THE NIMBUS II DATA CODE EXPERIMENT

TECHNICAL NOTE NO. 1
CONTRACT NO. NAS5-10114

ADDENDUM, ERRATA and OPERATIONAL MODIFICATION
for the NIMBUS II DATA CODE EXPERIMENT
(Technical Note No. 1)

Page 14, Figure 5a and Page 22a, Figure 5c

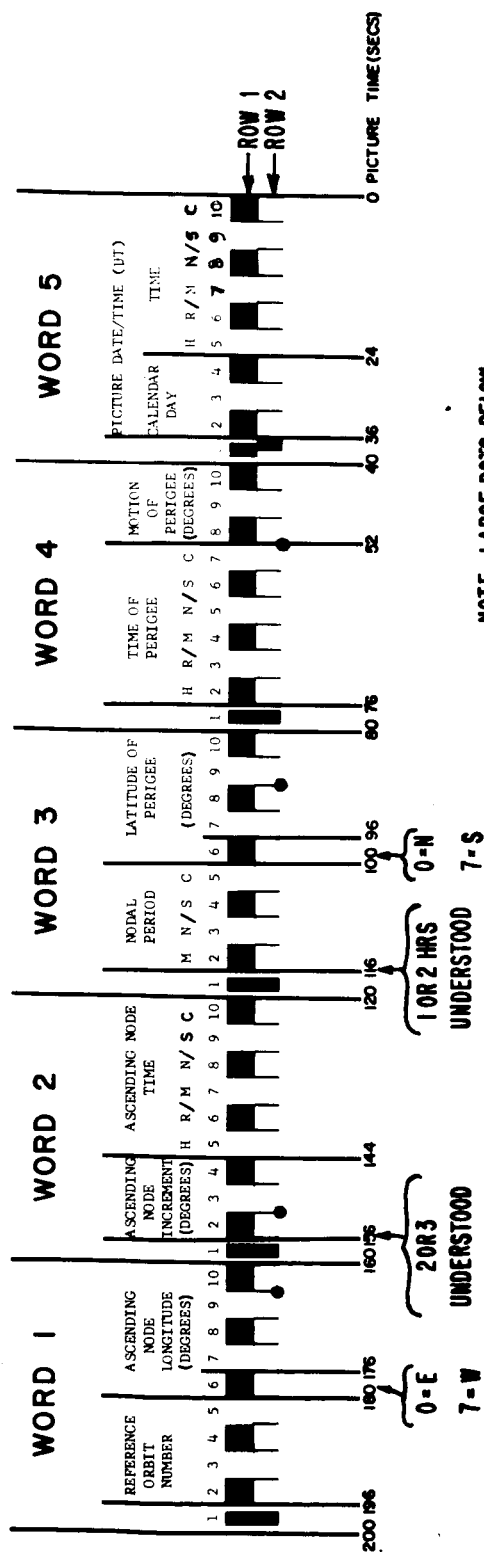
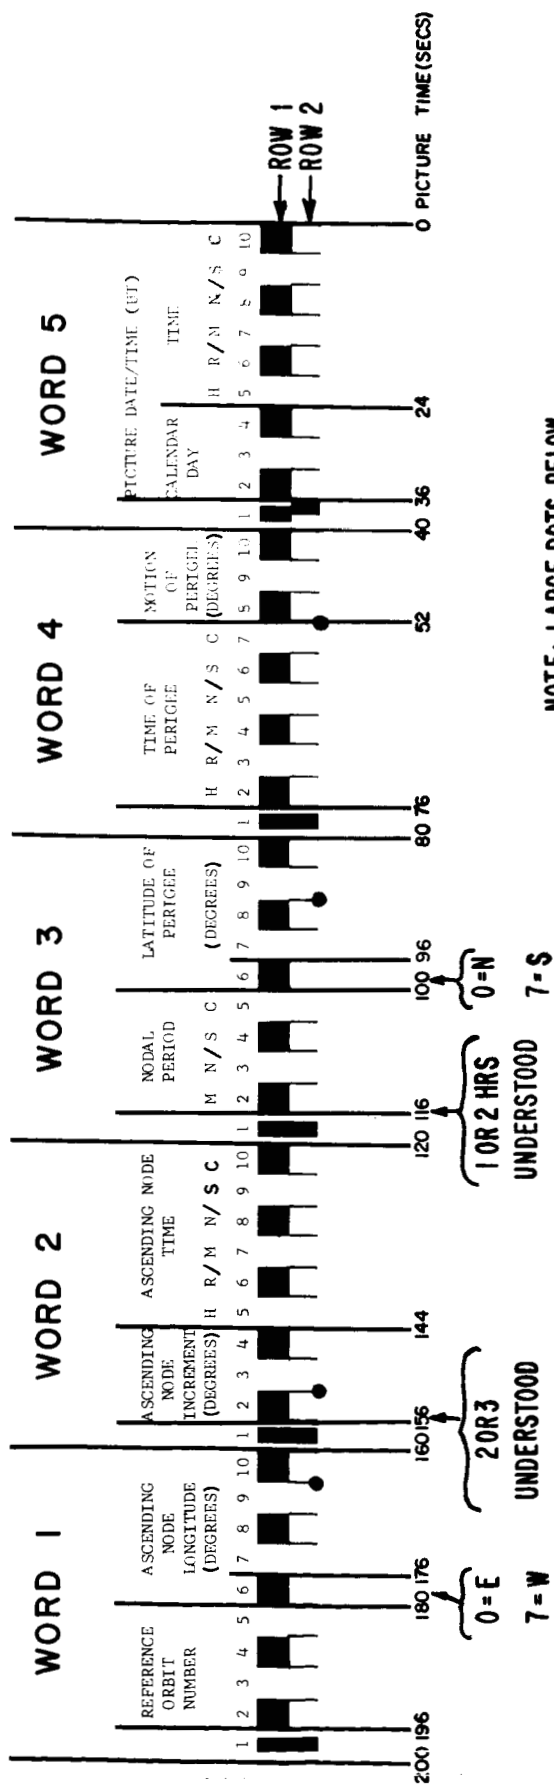
Change "0 Picture Time (Secs)" to "0 ELAPSED TIME (SECS)"

Add: "The numbers in the ELAPSED TIME (SECS) row indicate the elapsed times in seconds from the beginning of the scan of the first raster line of video to the Character Blocks illustrated."

Page 40, Figure 9, Right-hand Diagram

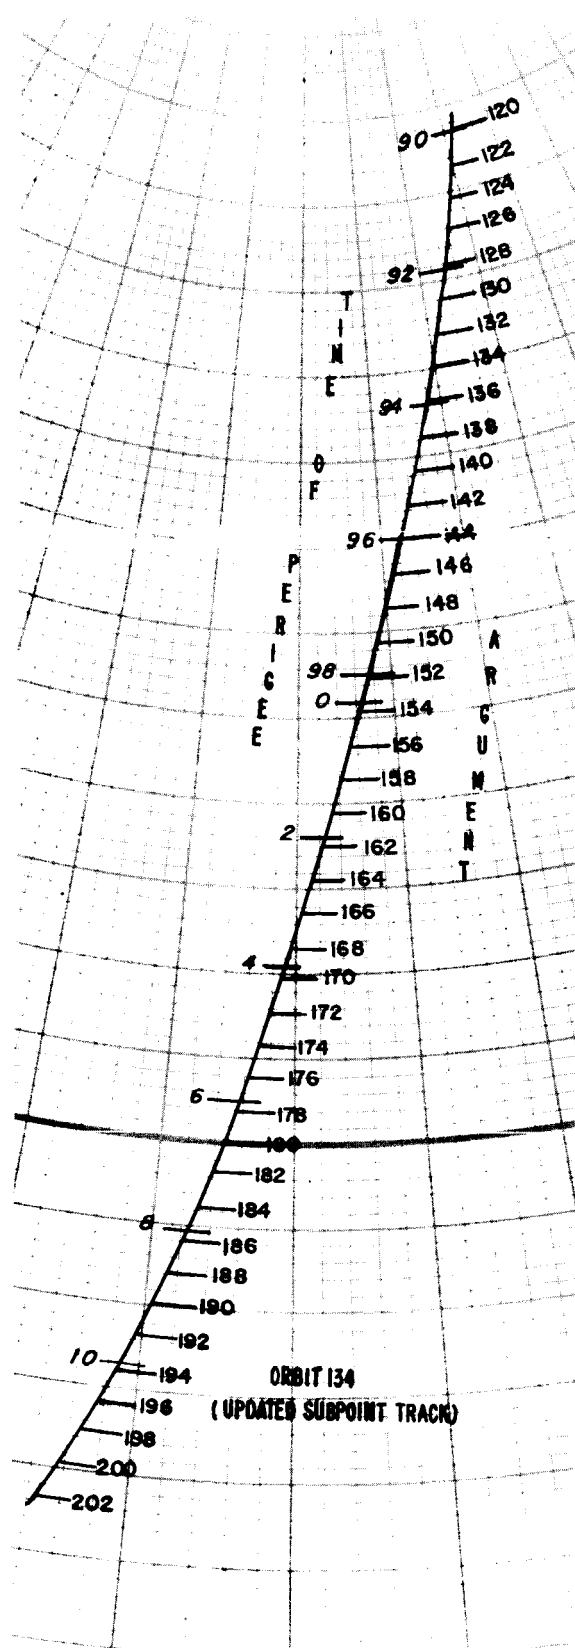
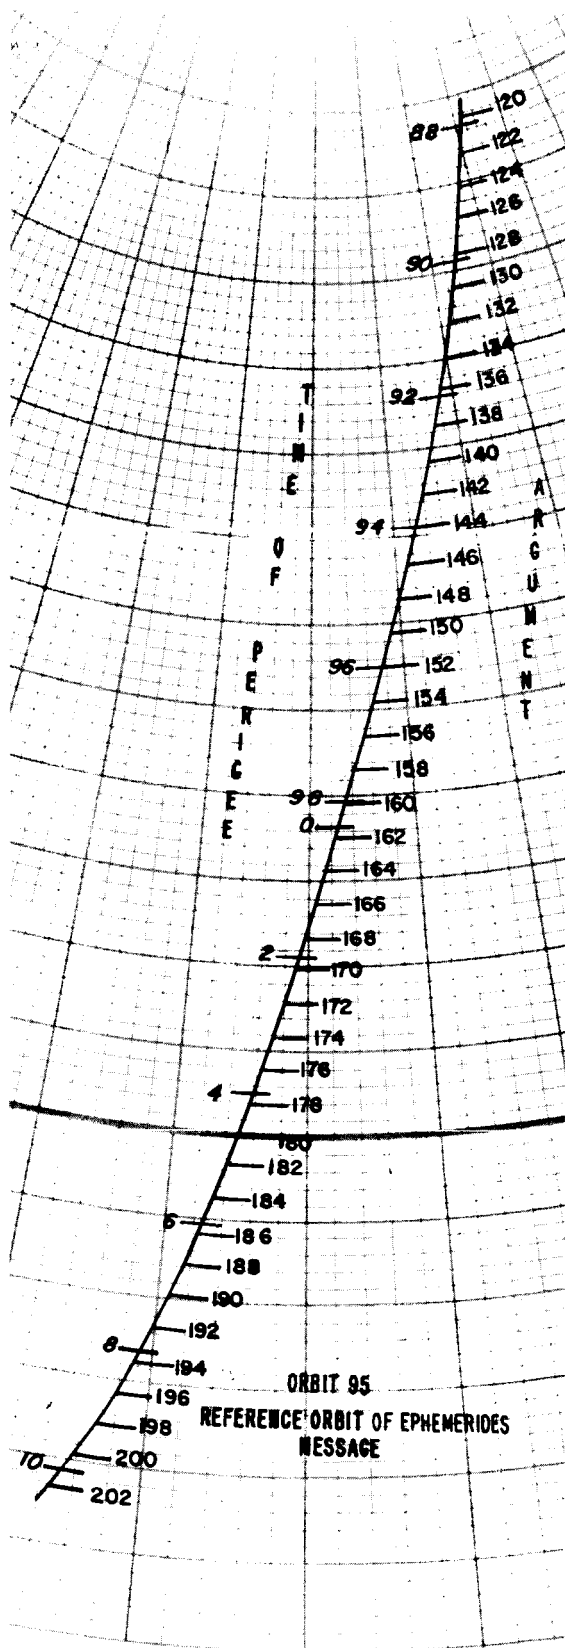
This diagram should be adjusted to show the errata values inserted on Page 39.

Page 42, Figure 10a

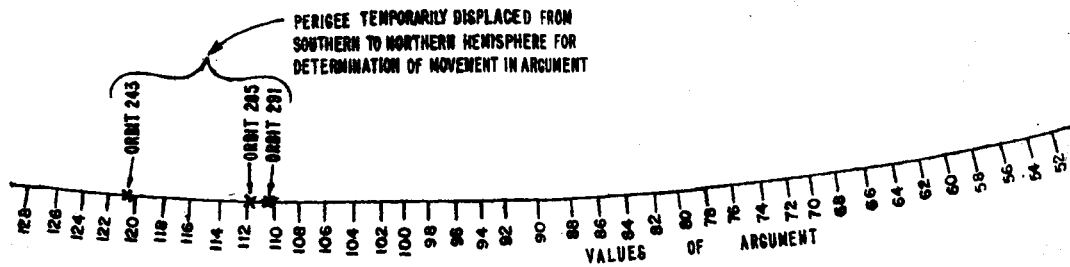
Delete "ORBIT 291 and its perigee point"

This Figure should be adjusted to show the errata values inserted on Page 41.

Page 45, Figure 11 and Page 46, Figure 12

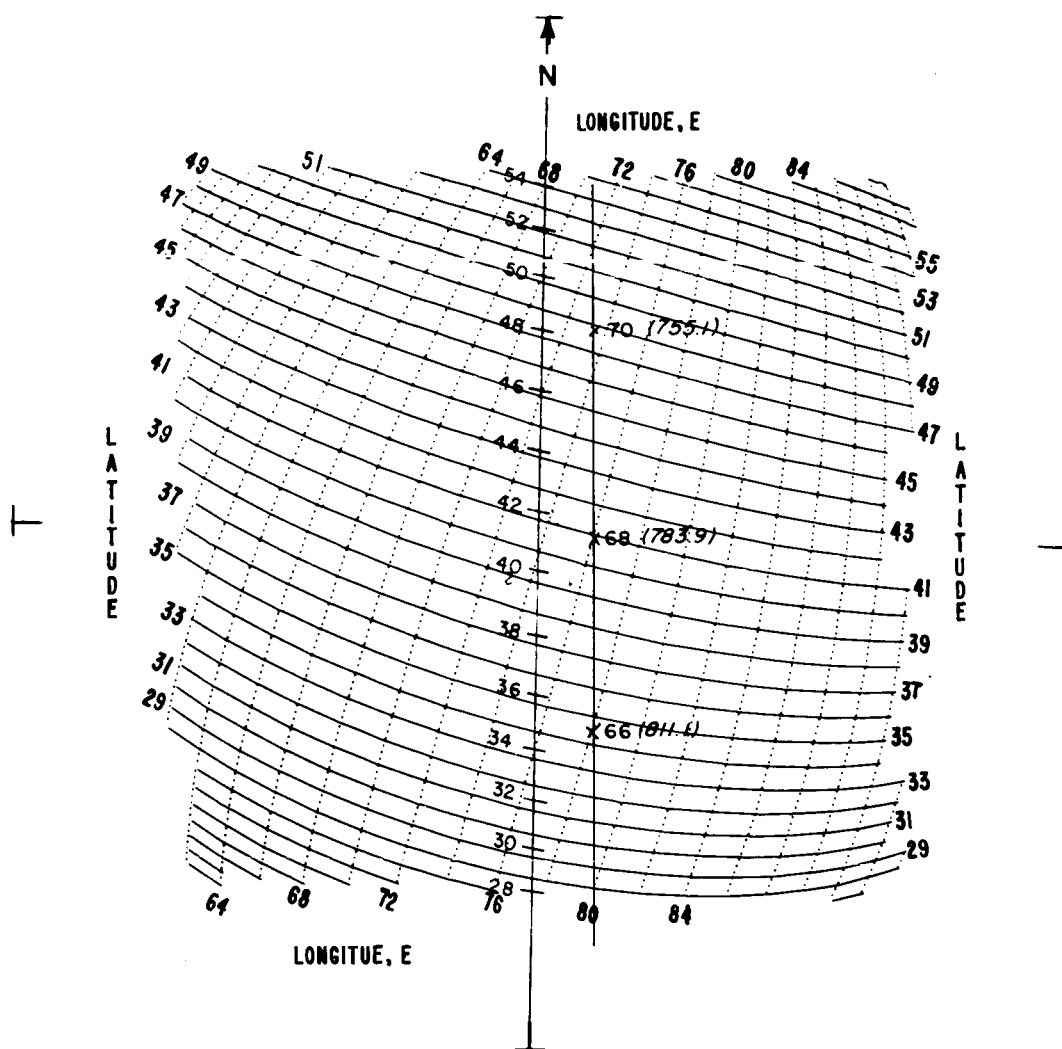
Change "longitue, E" to "longitude, E" in the lower left of the grids
